Update to Urgent Field Safety Notice

Medtronic HeartWare™ HVAD™ System

Power Source Lubricant Servicing

Medtronic reference: FA817 Phase III

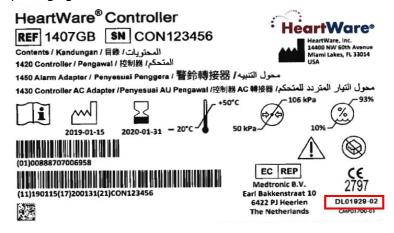
Controller Kits (Models 1400, 1401, 1407) containing an AC Adapter (Model 1425 or 1430) that are lubricated during manufacturing are identified by device label number, DL01929-02, as shown by location of the red box on the packaging label below.

We are writing to inform you that Medtronic has obtained the necessary regulatory approval for lubricant to be applied to the connectors of all HeartWare™ HVAD™ System power sources (Battery, AC Adapter, and DC Adapter) during manufacturing. Power sources identified and listed in the table above will be lubricated during manufacturing, prior to distribution; as a result, field application of lubricant will NOT be needed going forward.
